TITLE: BEAKS MI Peaks TH PWM Sandwich version		REV: 1.1
	Company: Sourcery Studios	Sheet: 1/1
	Date: 2021-07-01      Drawn By: Kristian Blåsø

TITLE: BEAKS MI Peaks TH PWM Sandwich version		REV: 1.0
EasyEDA	Company: Sourcery Studios	Sheet: 1/1
	Date: 2021-10-19	Drawn By: Kristian Blå sol

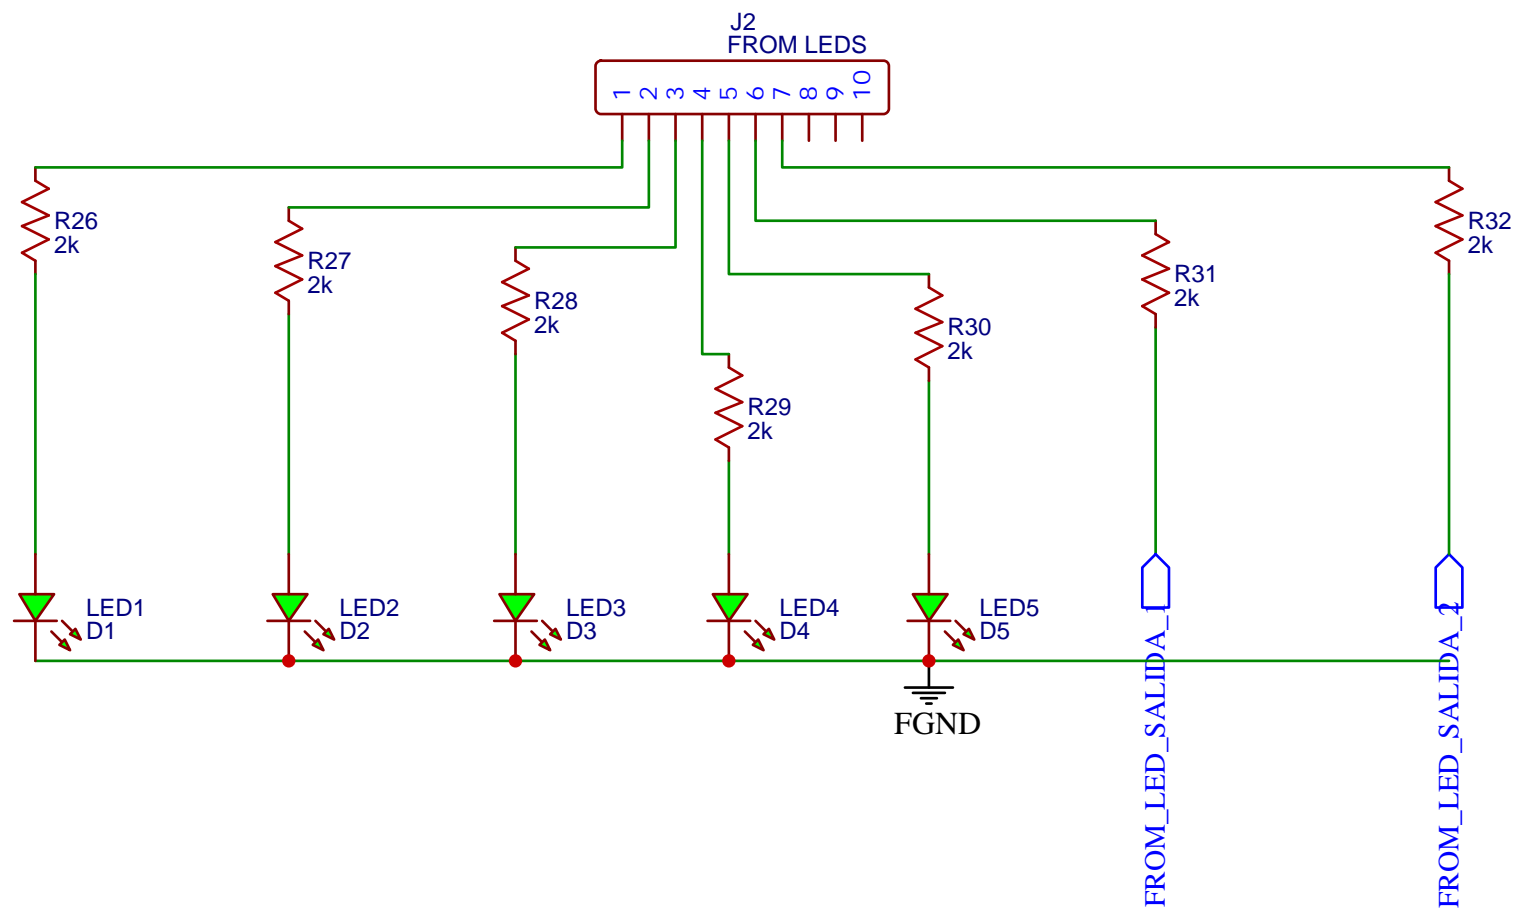
V0.2

- Turned all Pots around.
- Changed all buttons which were ALL wrong.
- Bigger mode and split buttons.
- Added a stud to keep front panel in place when pushing split and mode with alps pots. C130896 stud

V0.3

- Mode and split was still wrong. Changed place. DONE!
  - Output 2 isnt working? U2.2 wrong orientation. DONE!
  - TRIG LEDs not working wrong orientation? DONE!
- Ändrat C10 fr 033 till 10u

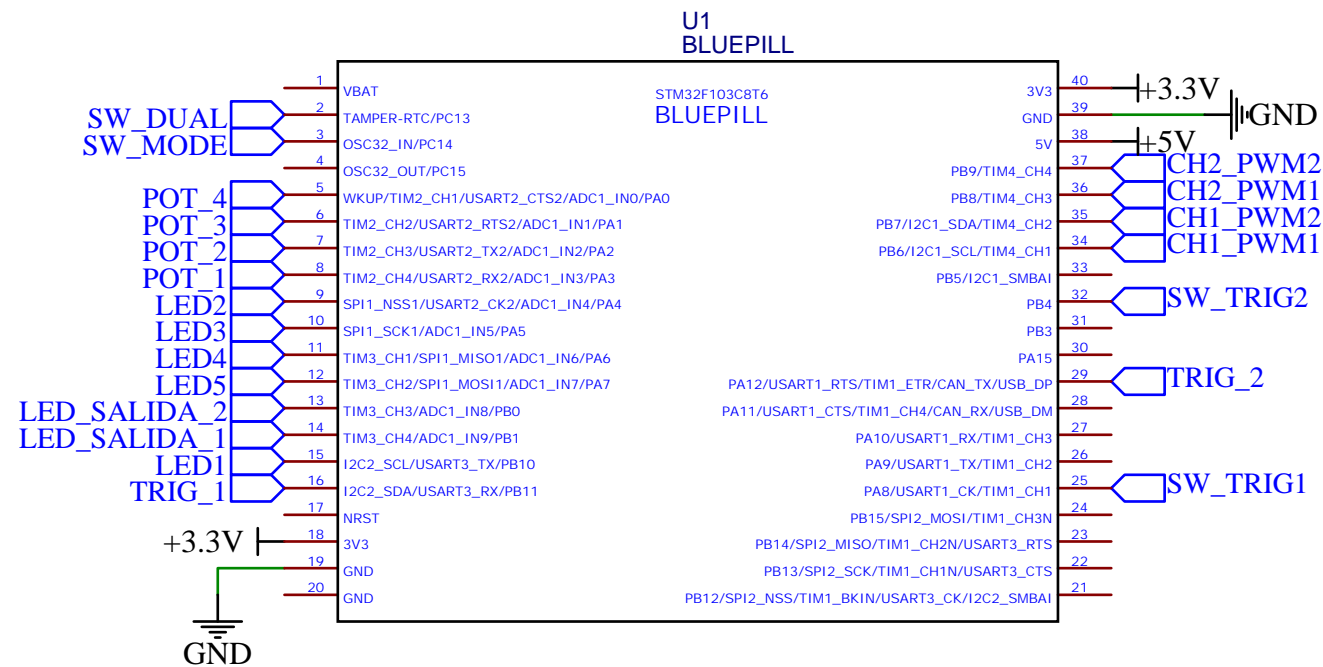
221219 sleeve to ring connection?  
Its on the original schem so have it  
(but mono jacks ofcourse)
